N472NAS2

# TECHNICAL BULLETIN

Service Action: Windshield Molding Tapping Noise

MODEL:	MODEL YEAR:	VIN:
Defender (LE)	2020	000584-008252

E266562

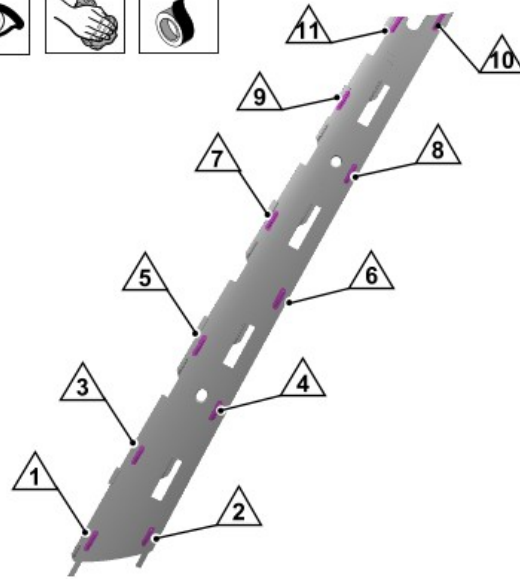
Locate the 11 windshield molding retaining ribs as shown highlighted.

- Clean the area around each windshield molding retaining rib.
- Apply felt tape to cover each of the 11 windshield molding retaining ribs as shown.
